PRODUCT CHANGE NOTICE

PCN Number: 2022-PCH-01

Issue Date: 05/27/2022

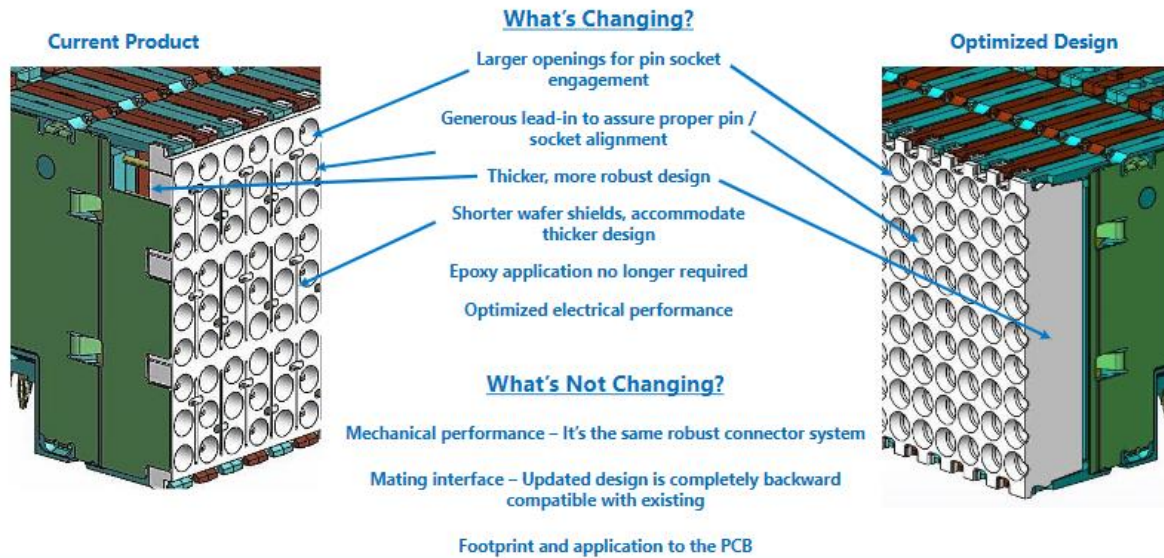
The Faceplate has been thickened to eliminate the epoxy from the assembly process, improve the faceplate retention, and improve the manufacturability of the product. The new KVPX connectors were qualified to MIL-DTL-55302G and passed all testing. The qualification report is available upon request.

The face of the connector has been extended from 21.3mm (0.839in) to 21.73mm (0.856in) a difference of 0.43mm (0.017in) to make the faceplate more robust. The hole diameters in the faceplate have been increased to allow for more lead-in for the mating pins to the sockets in the backplane. The side shield has been shortened to accommodate the thicker faceplate.
